EDMS NO.
1973905

REFERENCE
LHC-TCAP-EC-0001

ENGINEERING CHANGE REQUEST

Installation of New Passive Absorbers (TCAPM) for Warm Magnet Protection in IR7

Figure 1 — Illustrative view of the present (top) and post-LS2 (bottom) layouts of the IR7 Q5 [2,3]. The new TCAPM is represented by the brown box immediately upstream of the MQWA.D5, installed in the space freed by the removal of the MQWA.E5. A specular layout is planned for beam 2.

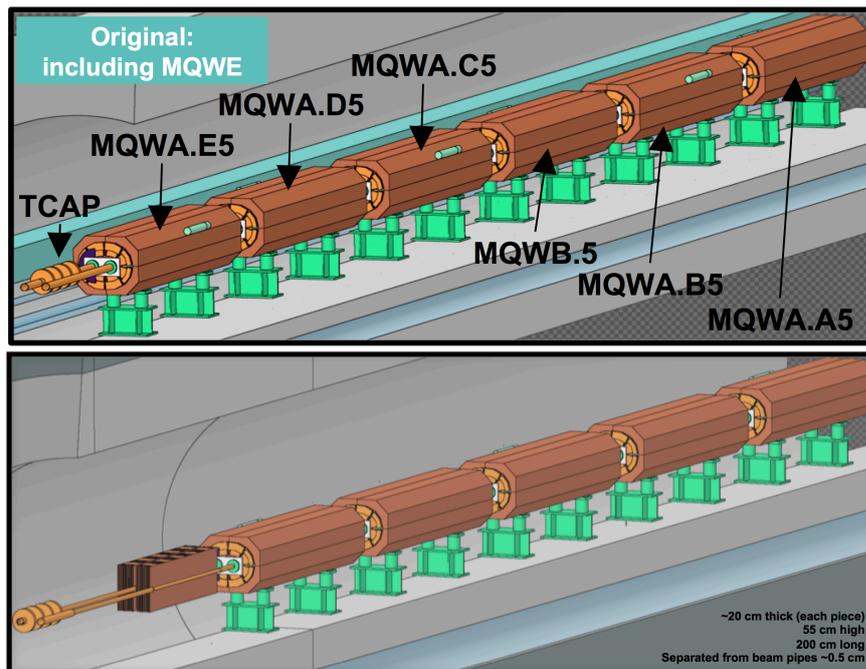
Details of mitigation plans for the absorbed dose of warm quadrupoles and dipoles in the betatron cleaning insertion (IR7) of the LHC can be found in [1]. Mitigations include the removal of the first (along the incoming beam direction) MQW module of the Q5 assemblies at either side of IP7. This leaves the subsequent magnets more exposed to radiation doses. In order to make the intervention effective for the overall dose reduction, an upgrade of the passive collimation system is required. As a design goal for this upgrade, we set the design requirement that all remaining 5 magnets should receive doses not exceeding the levels that they receive in the present layout. This requires adding one new passive absorber per beam, called TCAPM (Target Collimator Absorber Passive Mask), at the locations of the magnets that will be i.e. at the location of the MQWA.E5.

The present passive collimator TCAP (installed upstream of the present MQWA.E5, see Fig. 1) will remain in place and the new passive absorber TCAPM will be added. The latter is outside the vacuum, contrary to the existing passive absorbers. The same elliptical chambers as the present MQW one will be used in this area. The vacuum layout is described in detail in [1] so we focus here only on the new absorber outside vacuum.

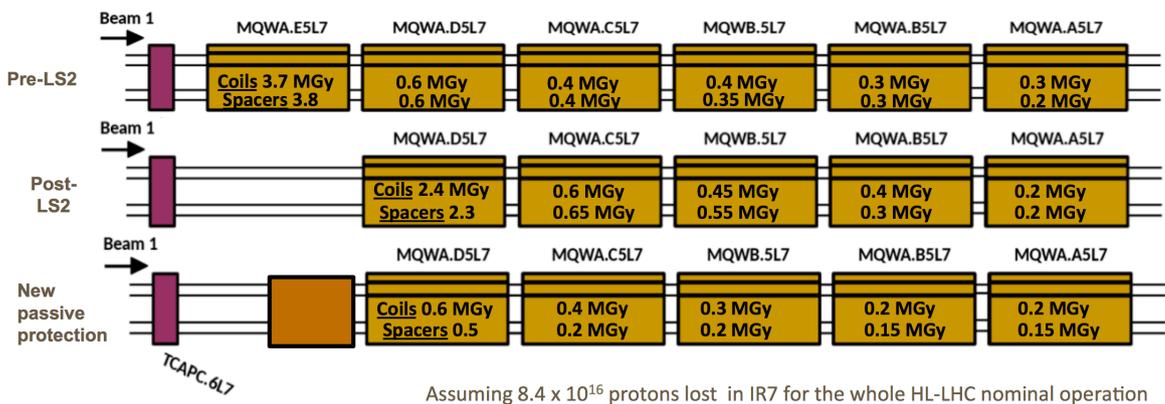
The computed doses in all modules of the Q5 magnets for beam 1, estimated for the whole lifetime of the HL-LHC project [7], are illustrated in Figure 2 for three different layouts [2,3]:

- Present layout (top graph);
- Hypothetical layout without collimation upgrade after magnet removal (middle);
- Proposed post-LS2 layout (bottom) with TCAPM.

Dose values are estimated both for the coil and for the spacers [1]. Note that for all cases, the present TCAPC.6L7.B1 collimator remains at the same location, as this was found to produce good performance. This also avoids intervening on a radioactive collimator. It is clear that without an improvement of the passive collimation layout (middle plot), doses on the downstream MQWs would be much higher than in the present layout. In particular, the dose on the coil spacers [1] of the most exposed magnet would be about a factor 4 larger. The proposed solution with TCAPM (bottom line) described in detail in the next section, solves this issue and brings the doses to an acceptable level.

Figure 3 — Overall design of the TCAPM. Lengths are given in mm. Courtesy of L. Gentini [8].

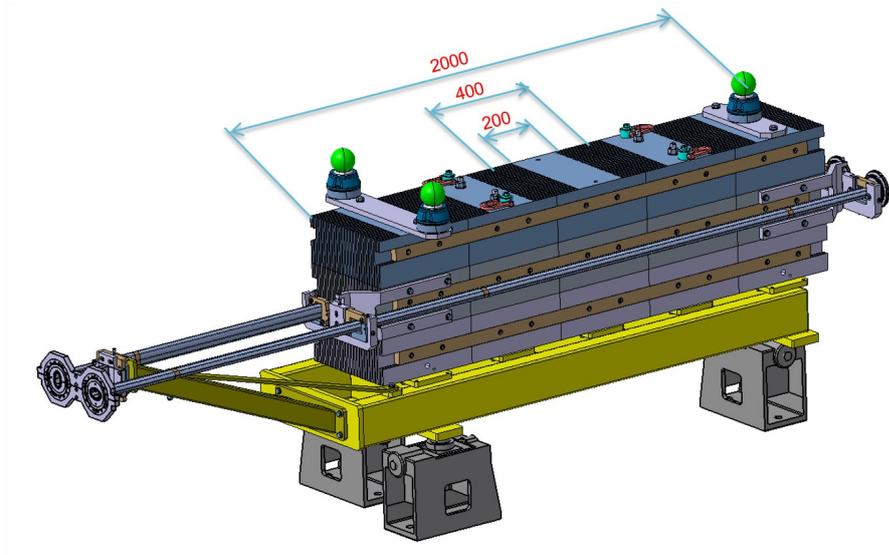
The new absorber's design [8] is shown in Figure 3. A new support that will be installed under the vacuum chamber will house a modular structure made of steel blocks, assembled together to fill a volume that ensures adequate shielding of the downstream magnet. The absorbing part consists of three block assemblies shown in Figure 4. The assemblies 1, 2 and 3 weigh respectively 781 Kg, 756 Kg and 779 Kg, for a total of about 2590 kg with the support. The TCAPM transverse cross section is shown in Figure 5. The absorber assemblies are mounted around the elliptical beam pipes in a way that leaves minimum empty spaces. A preliminary integration layout is shown in Figure 6. The longitudinal central positions of the new passive absorbers are 19852.4064 m for B1 and 20135.9184 for B2.
